City of Plymouth Plan Commission

The City of Plymouth Plan Commission will have a meeting on **Thursday July 10, 2025 at 6:00 PM in Room 305**, City Hall, and Plymouth, WI.

RE: **Site Plan Seeking Approval;** 115 Plymouth Street, St. John the Baptist Congregation, for the alteration of an existing parking lot. St. John the Baptist Congregation (enclosure)

RE: **Site Plan Seeking Approval:** Parcel number 59271822750 (southeast corner of STH 57 and CTH PP), Sargento Cheese Inc, regarding proposed plans to construct an approximately 384,000 square foot industrial facility in the H-I Heavy Industrial zoning district. Sargento Cheese/Kraemer & Davis (enclosure)

CIVIL EXISTING SITE AND DEMOLITION PLAN

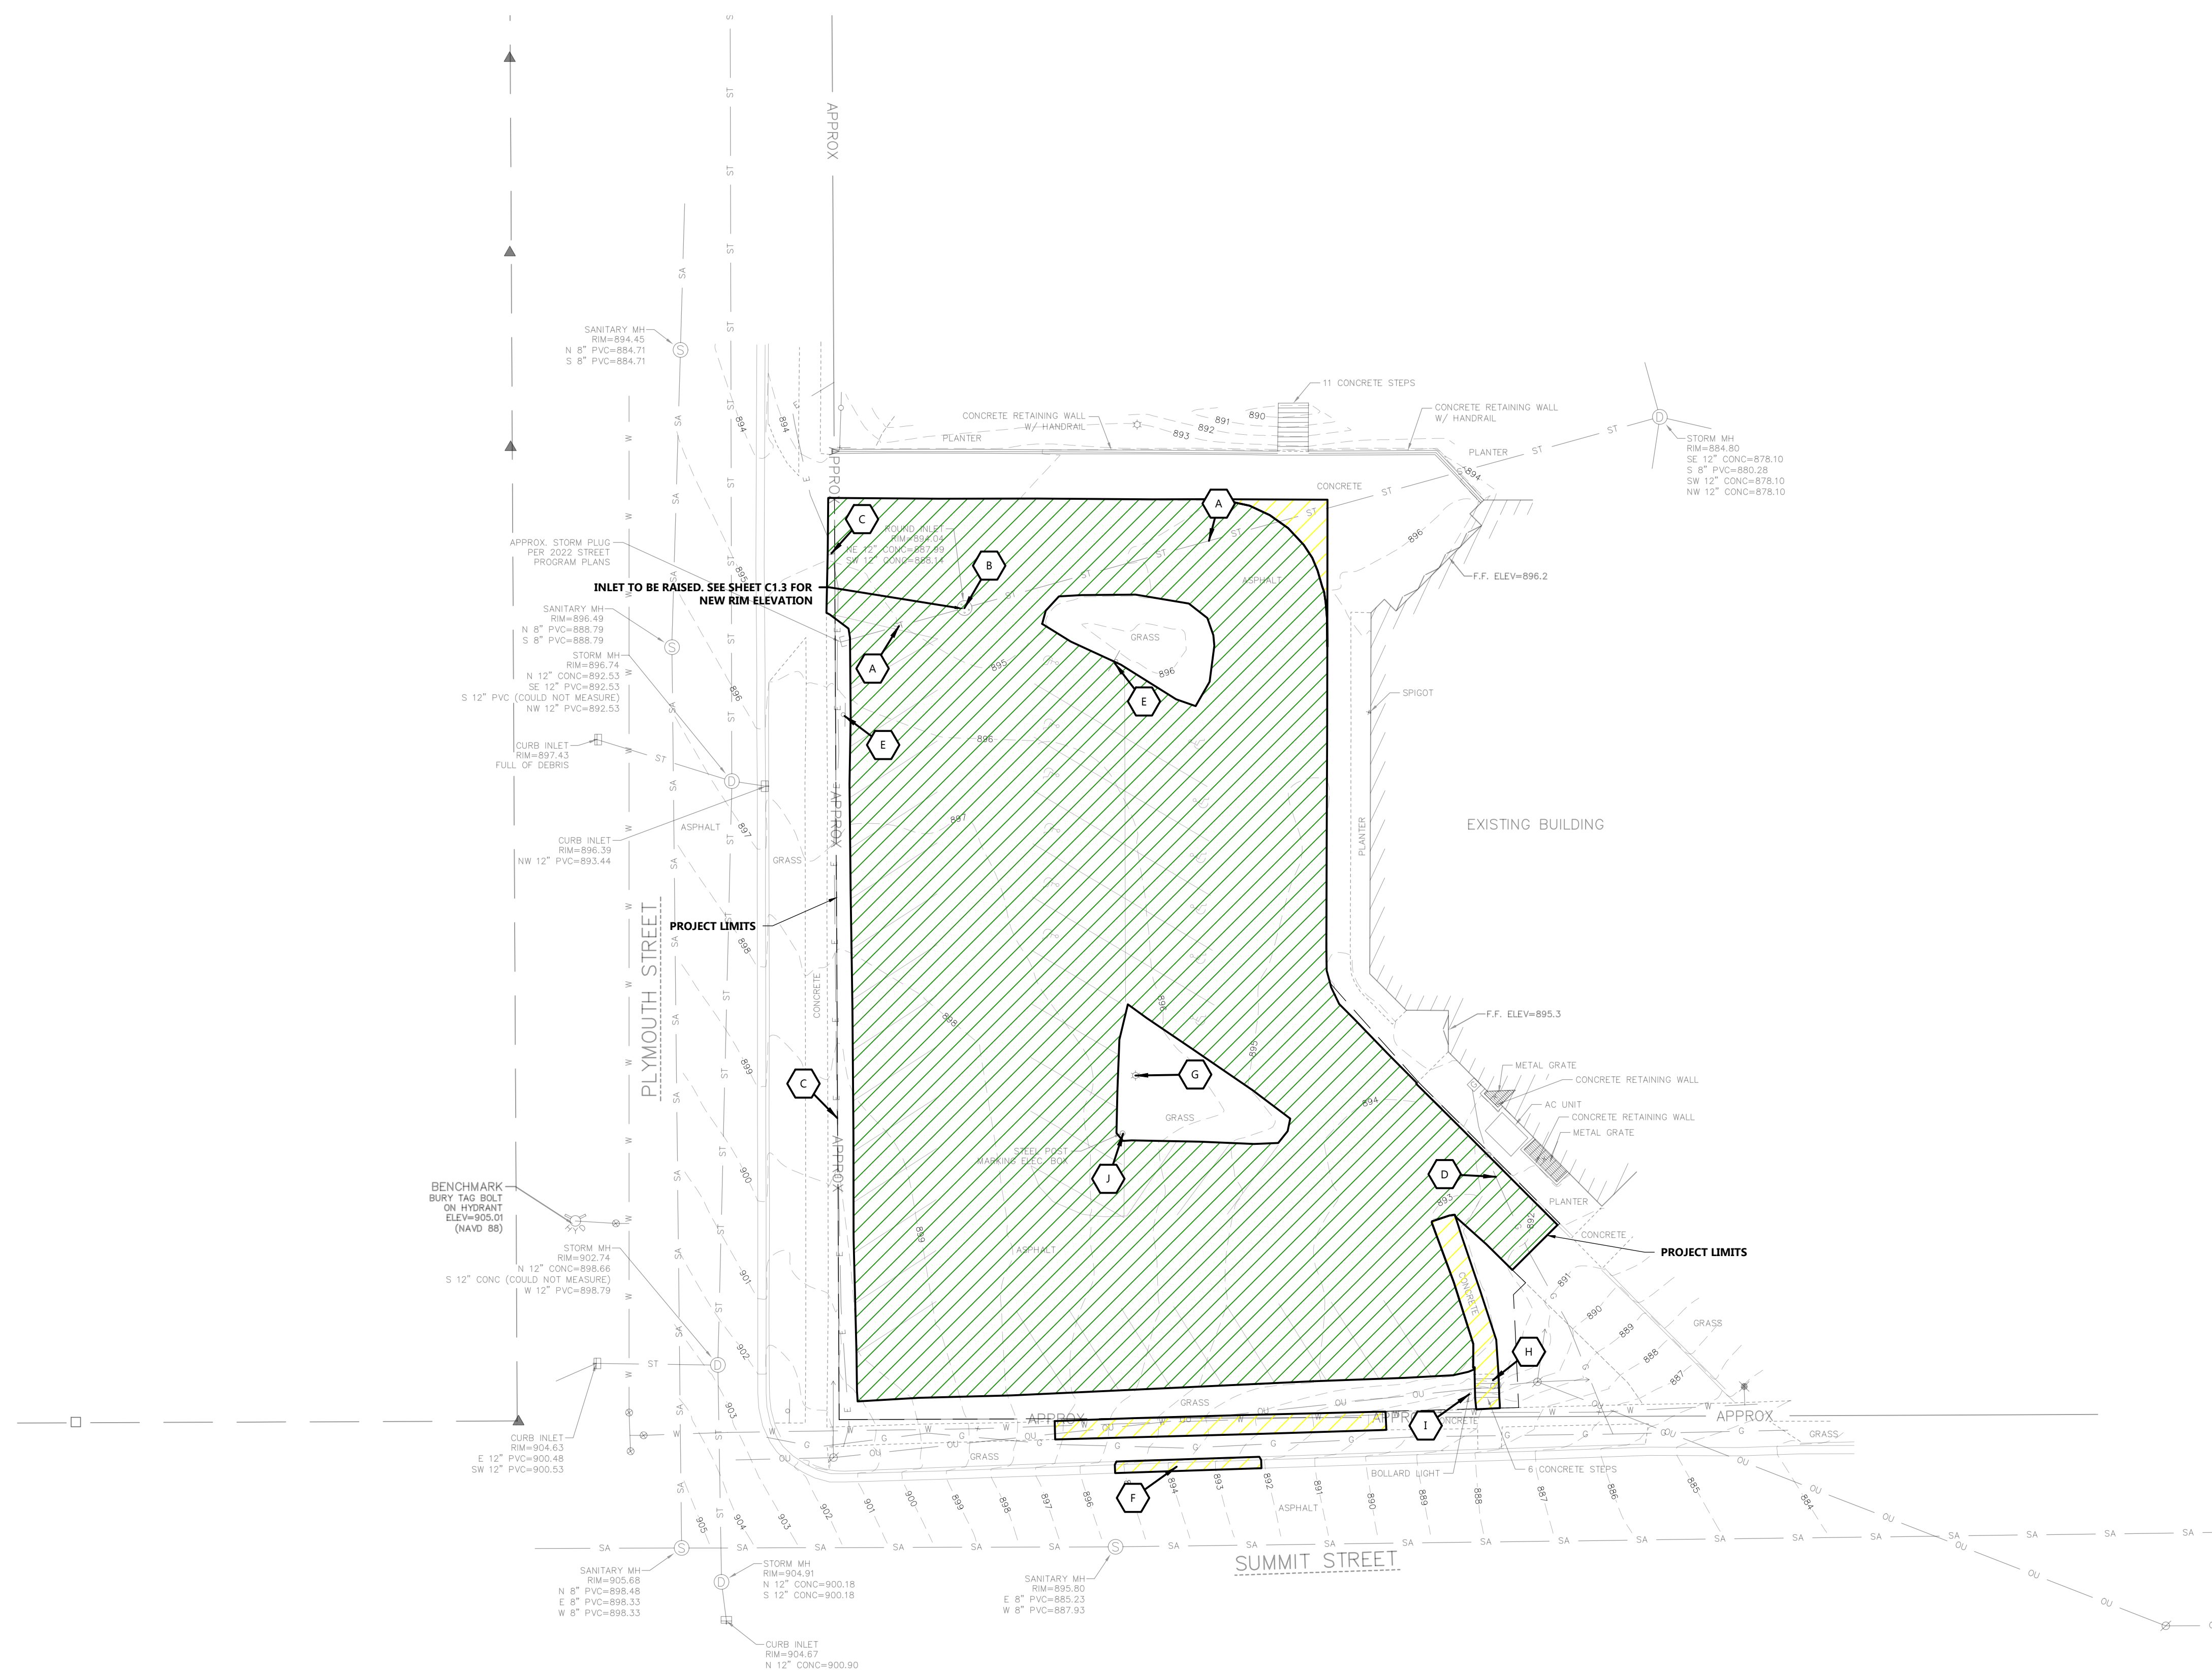
Both Public Works Director Austin and Chief Pafford reviewed the proposal and have no concerns. A driveway permit will be required to be granted for the new driveway opening along Summit Street. Please note that the existing driveway approach is planned to remain, but with no connection to the parking lot.

Staff recommends the Plan Commission the parking lot alteration project for St. John the Baptist as presented, while waiving the fencing requirement and the parking minimum requirement as allowed in Sec. Sec. 13-1-173(f)(2) of the municipal code for group developments.

**SITE LIGHTING
PHOTOMETRICS
PLAN - NORTH**

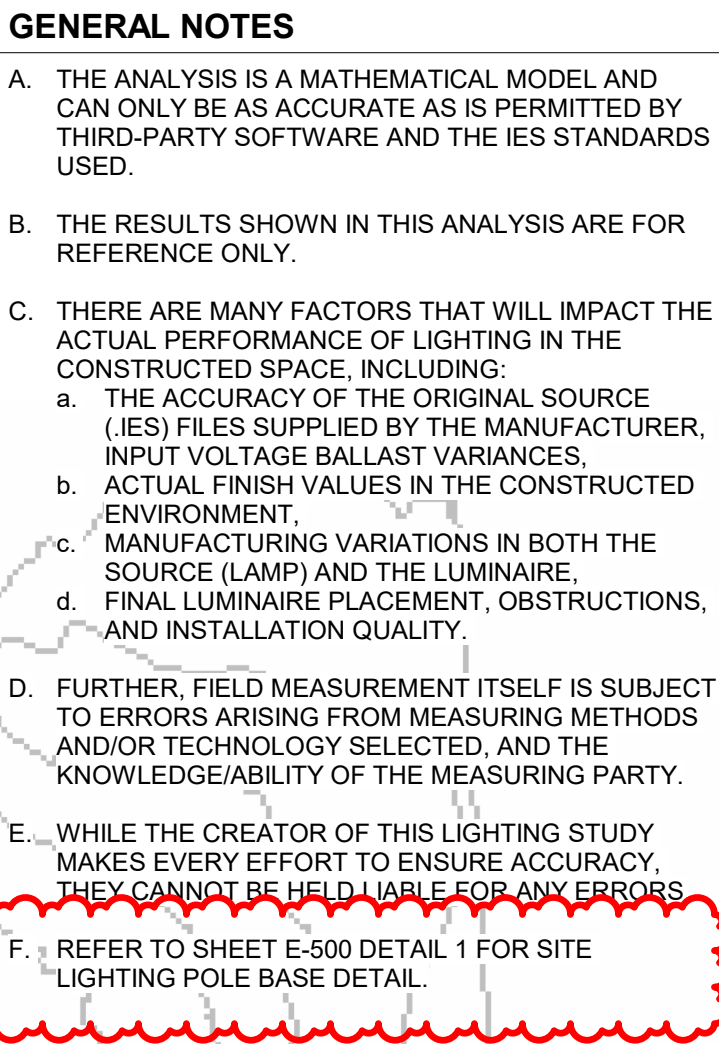
The applicant has provided a lighting plan for both the north and south side of proposed building. The lighting plan has been reviewed by the Building Inspector for conformance to international building code (IBC) standards and it was found these requirements have been satisfied.

OVERALL GRADING AND DRAINAGE PLAN

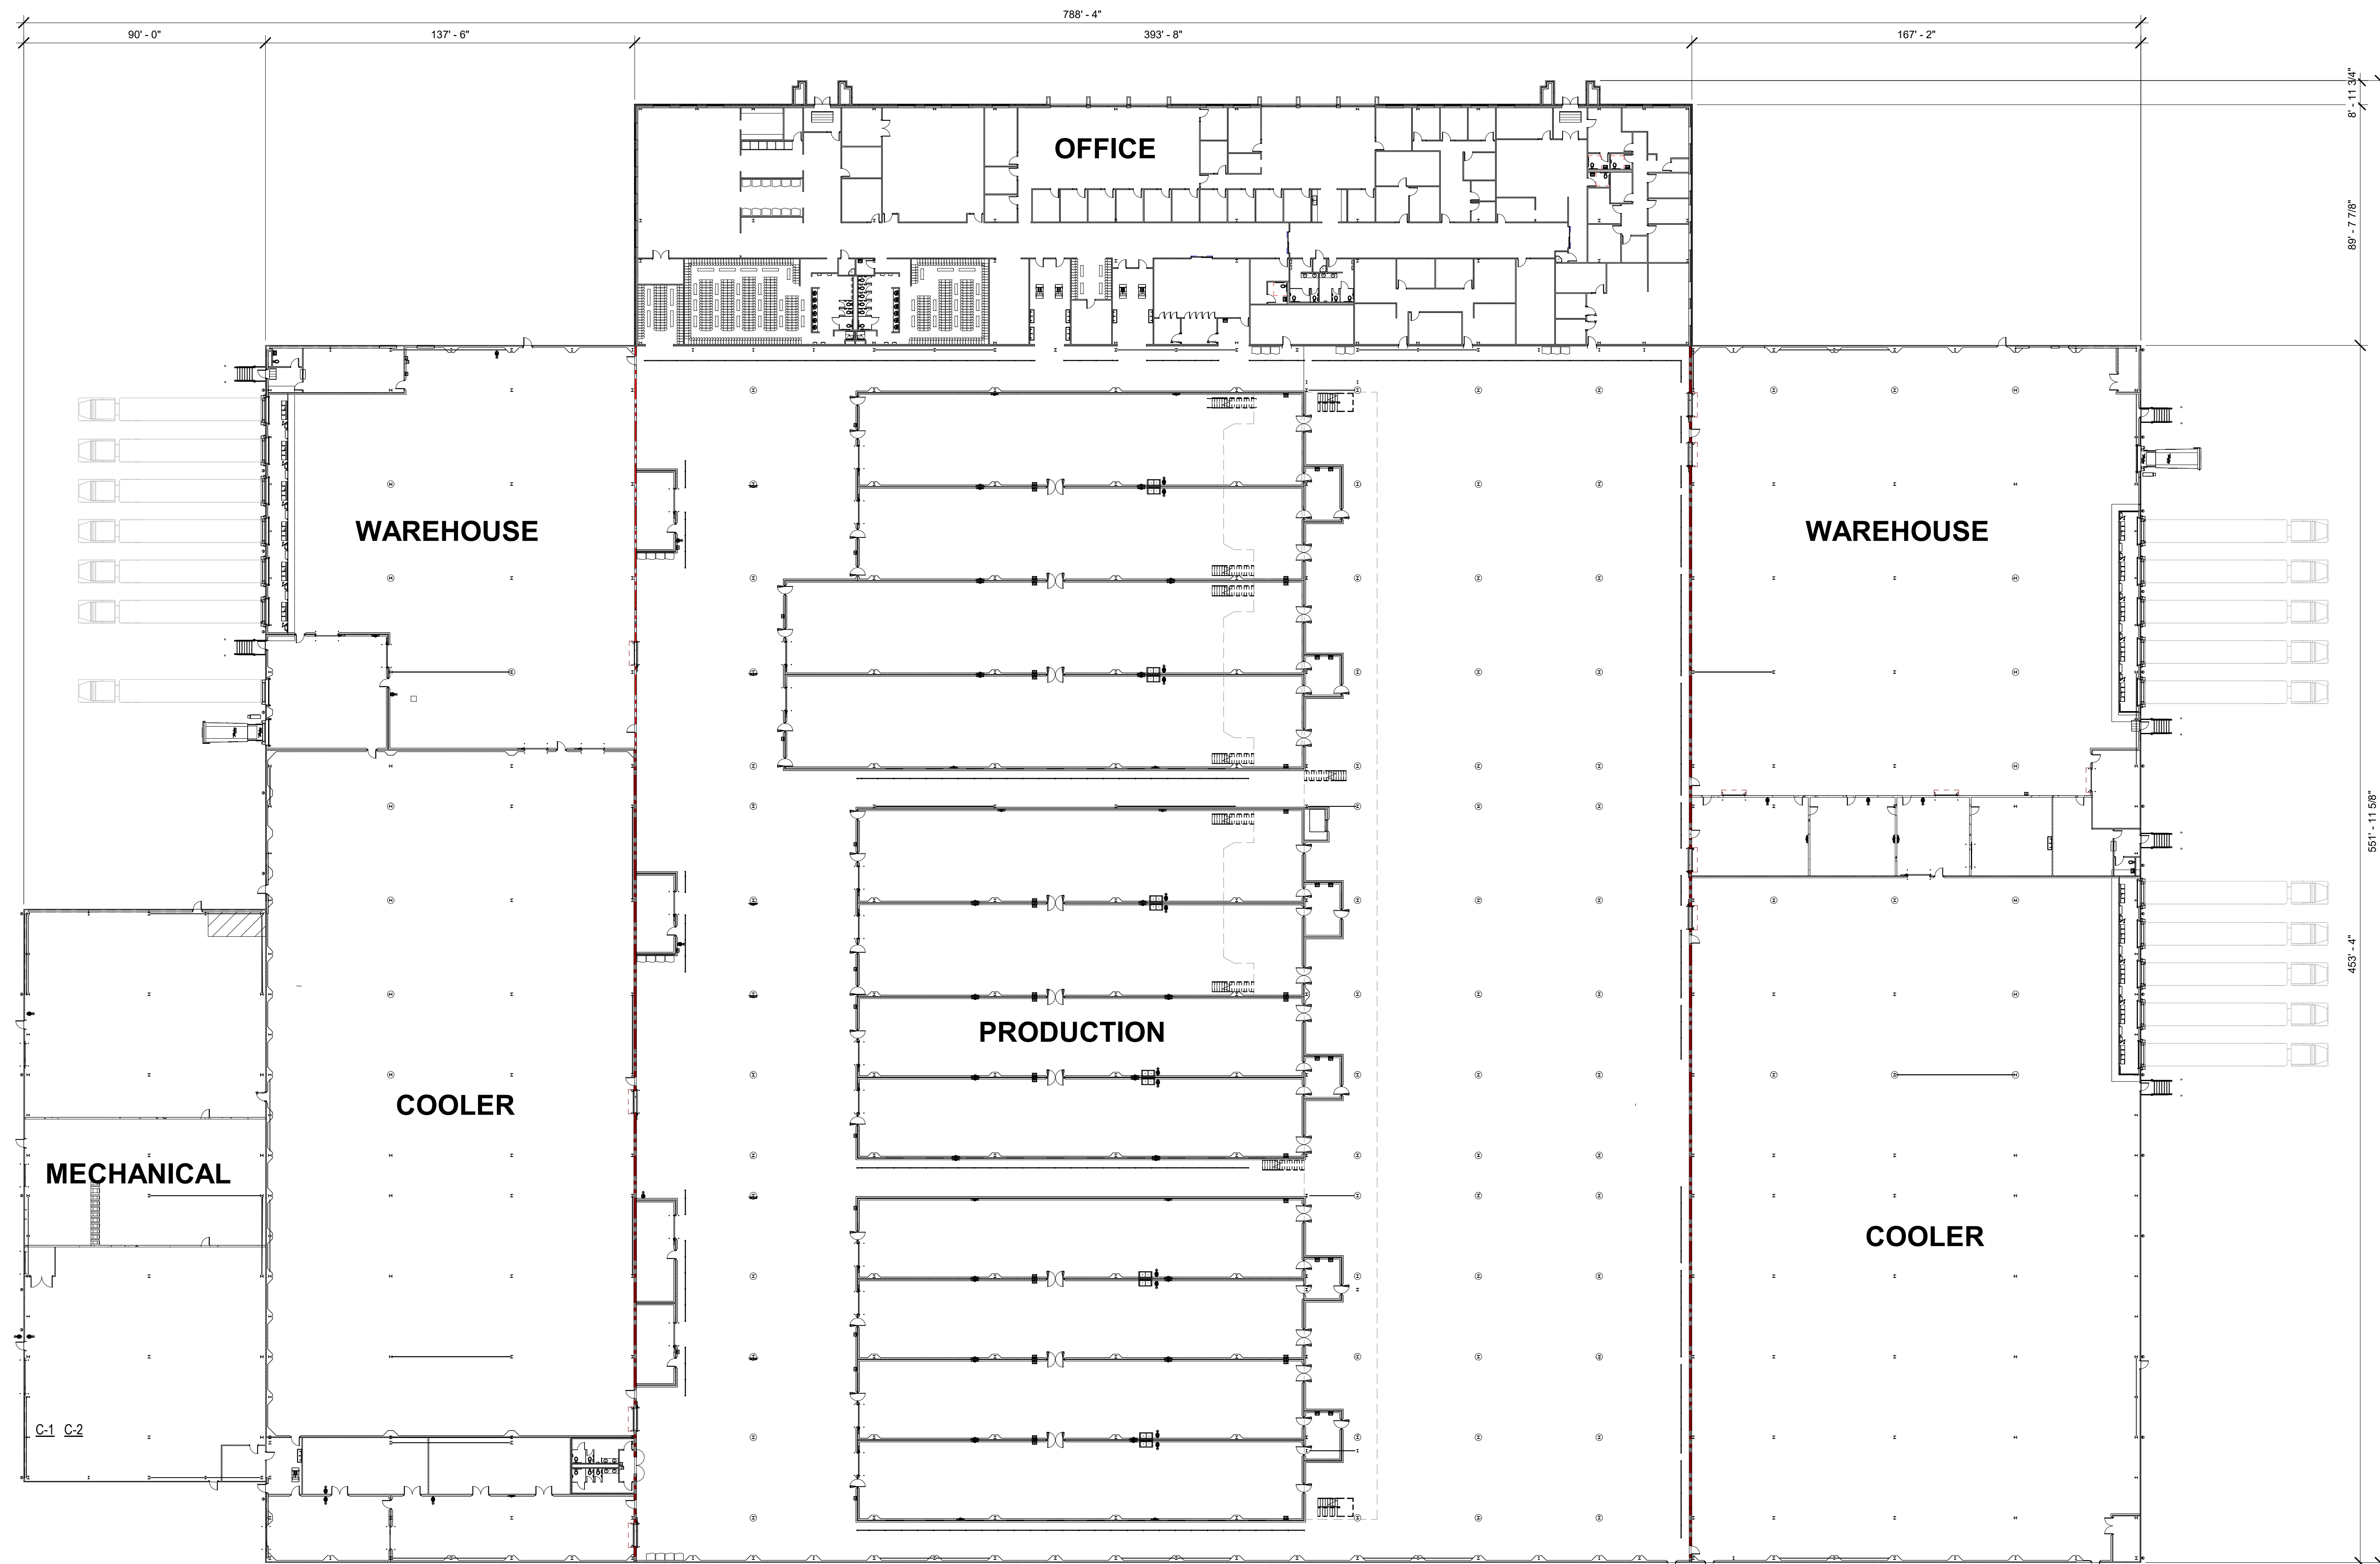
Stormwater Management Plan: A Stormwater Management Plan has been submitted, and the Public Works Director and Gray Engineering are finalizing the report. Approval from Plan Commission for the site may need to be contingent on an approved Stormwater Management Plan.

- Traffic Impact Analysis coming back to the Plan Commission for final approval once staff can review.
- Water Demand: Approval from Plan Commission for the site to be contingent on an approved utility plan by the Director of Public Works.
- Sanitary Demand: Utility is currently investigating capacity in the existing infrastructure. Approval from Plan Commission for the site to be contingent on an approved utility plan by the Director of Public Works.
- Stormwater Management Plan: Approval from Plan Commission for the site to be contingent on an approved Stormwater Management Plan.
